AMC Knit Composite Ltd. (Extension)

24 April 2024

2. Observations

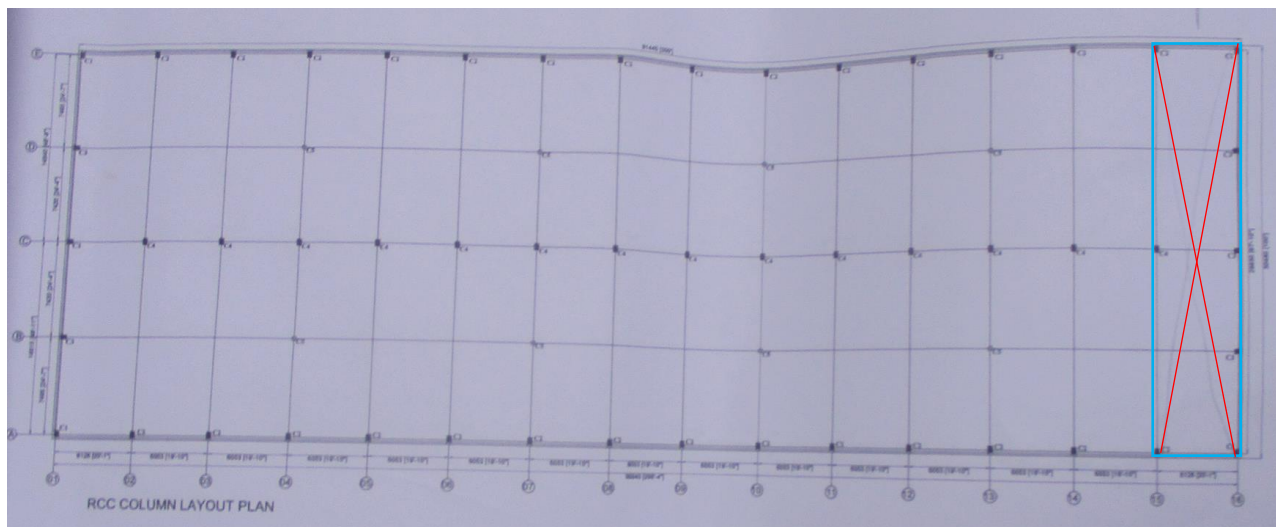
Observation-04: Building permit from local authority not available. (Yarn store shed, Utility Building, Fire Pump Room)

Description: During the inspection, a building permit from the local authority was not available for the Yarn store shed, Utility Building, and Fire Pump Room. The factory authority is required to collect building permits from the local authority for these buildings.
